**SOLICITATION AMENDMENT
MODIFICATION DE L'INVITATION**

Title - Sujet Centre des visiteurs Green Gables	
Solicitation No. - N° de l'invitation ED001-181274/A	Amendment No. - N° modif. 005
Client Reference No. - N° de référence du client R.081199.001	Date 2017-10-12
GETS Reference No. - N° de référence de SEAG PW-SPWC-024-4190	
File No. - N° de dossier PWC-7-40074 (024)	CCC No./N° CCC - FMS No./N° VME
Solicitation Closes - L'invitation prend fin at - à 02:00 PM on - le 2017-10-18	Time Zone Fuseau horaire Atlantic Daylight Saving Time ADT
F.O.B. - F.A.B. Plant-Usine: <input type="checkbox"/> Destination: <input checked="" type="checkbox"/> Other-Autre: <input type="checkbox"/>	
Address Enquiries to: - Adresser toutes questions à: Bysterveldt (PWC), Crystal	Buyer Id - Id de l'acheteur pwc024
Telephone No. - N° de téléphone (902) 940-7122 ()	FAX No. - N° de FAX (902) 566-7514
Destination - of Goods, Services, and Construction: Destination - des biens, services et construction:

LE PRÉSENT ADDENDA VISE À PRÉSENTER LES RÉPONSES SUIVANTES AUX QUESTIONS POSÉES PAR LES SOUMISSIONNAIRES.

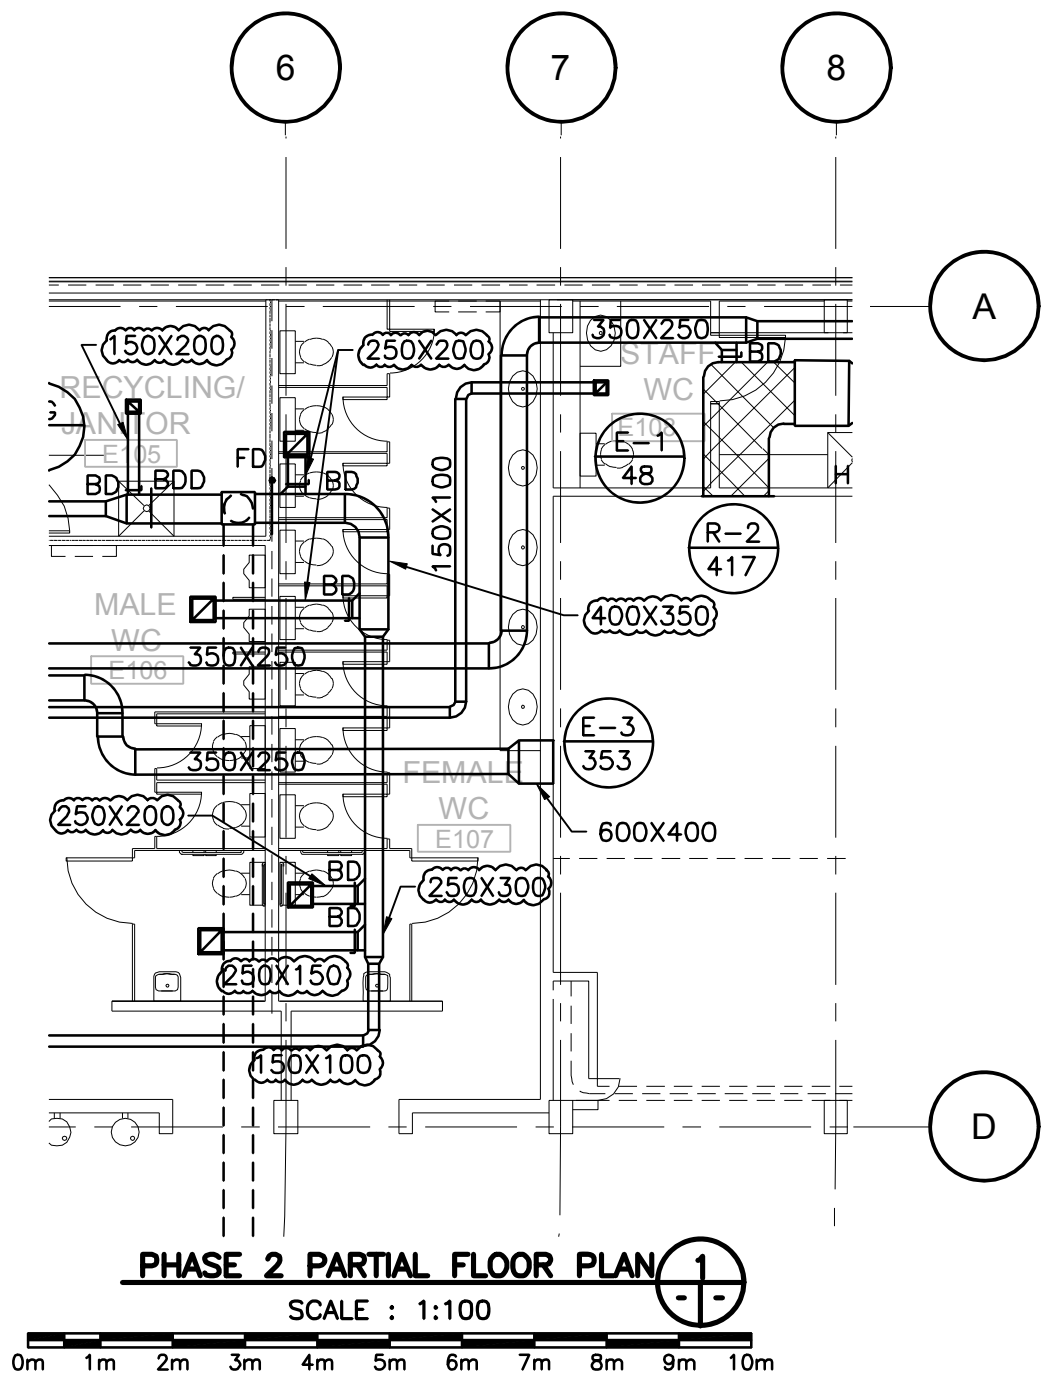
5. Reference Drawing M01: exhaust ductwork above WR's and Janitor Room to sized as per sketch MSK-01.
6. Reference Drawing M01: return grille at HRV-3 is named R-3.
7. Reference Drawing M01: return grille on wall in meeting room E116 is named R-4 and is louvered return grille 600 x 300.
8. Reference Drawing M01: return grilles R-1 in electrical room to be fire rated.
9. Reference Drawing M01: increase the size of HRV-1 intake louver L-6 to 900 x 800 with a 600mm deep plenum.
10. Reference Drawing M05, detail 5: Minimum bury depth to be 600mm. Slope at 1:100. HDPE duct to be used for all buried ductwork and to transition to galvanized steel immediately.
11. Drawing P03 Plumbing Schedule and Specification Section 22 42 00– Commercial Plumbing Fixtures – Par. 2.03.1.1 – Provide quarter-turn ball valve stops for all plumbing fixtures.

Mechanical: See new drawing MSK01 attached below.

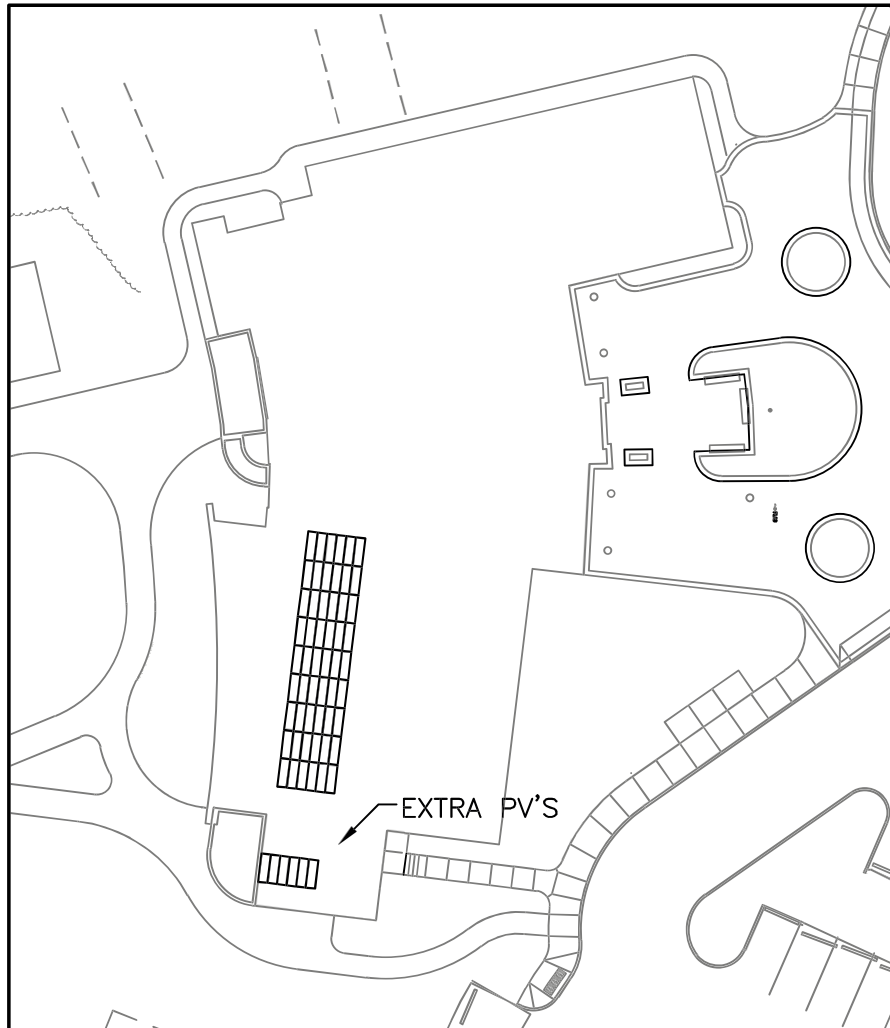
Reference Drawing ES01

1. Revise drawing per attached sketch ESK01.

designed	JAS	conçu
date	OCT-2017	
drawn	CRP	dessiné
date	OCT-2017	
approved		approuvé
date		
Tender		Submission
PWOSC Project Manager	Administrateur de projets TPSCC	
project number	no. du projet	
	R.081199.001	
drawing no.	no. du dessin	
	ESK04

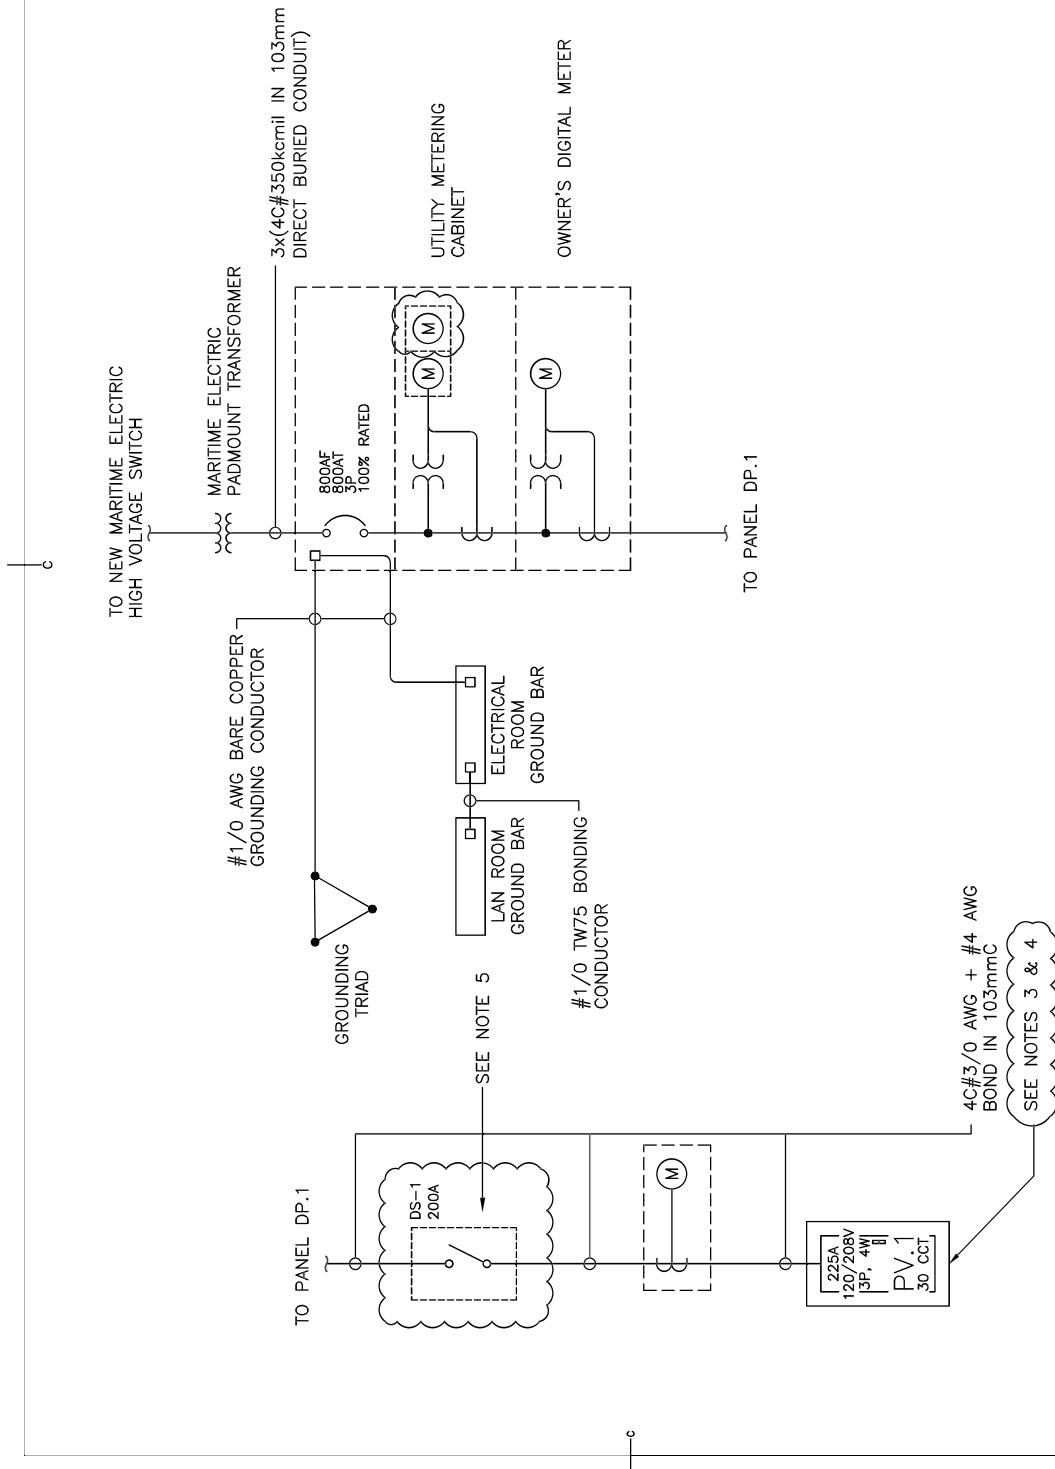
Reference Drawing EG07

1. Revise drawing per attached sketch ESK04

- NOTES:**
1. SPD BREAKER TO BE DETERMINED BY SPD MANUFACTURER.
 2. DIGITAL METER TO BE INTEGRATED INTO TPL. 1.
 3. MAIN BREAKER MUST HAVE SHUNT TRIP CAPABILITY.
 4. PROVIDE AND INSTALL ONE (1) 3-POLE BREAKER FOR 27/59/810/U PROTECTION RELAYS.
 5. DISCONNECT SWITCH TO BE CLEARLY LABELED "NET- METERING SYSTEM DISCONNECT"

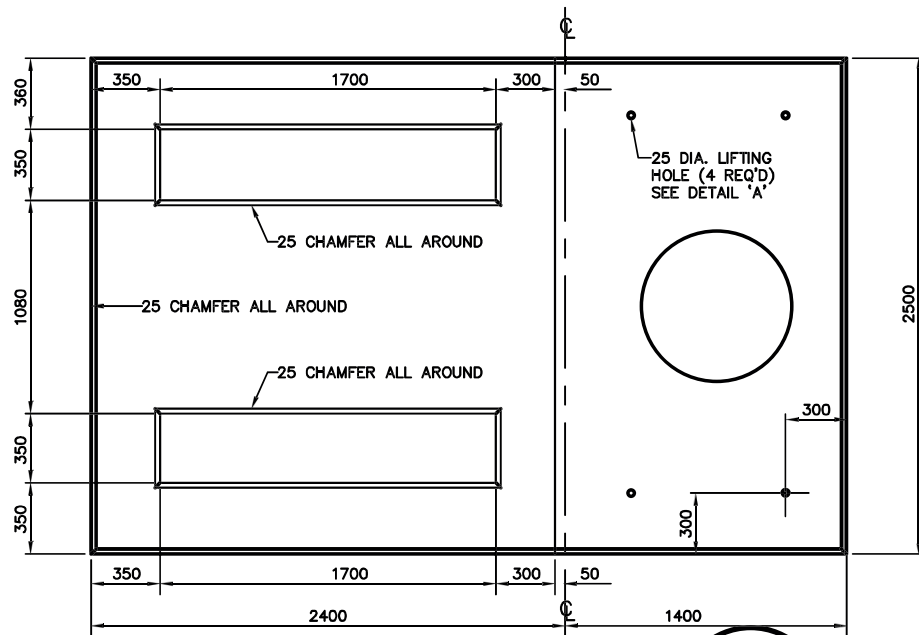
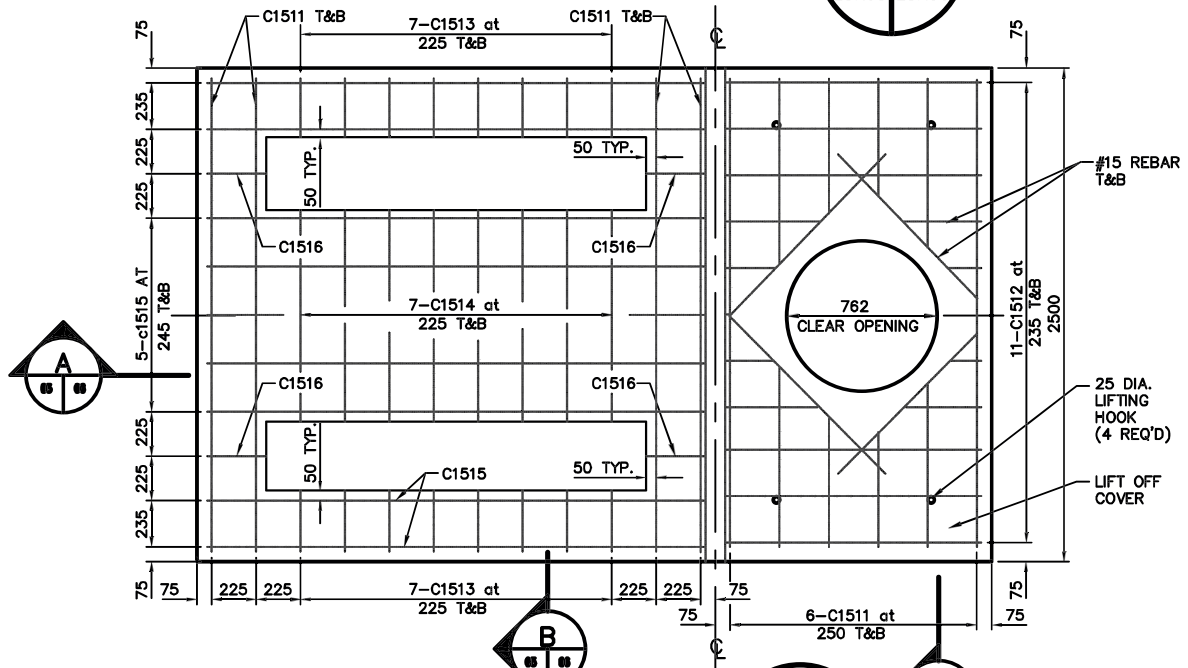
Reference Drawing EG02

1. Add Detail 7 per attached sketch ESK05.
2. Add Detail 8 per attached sketch ESK06.
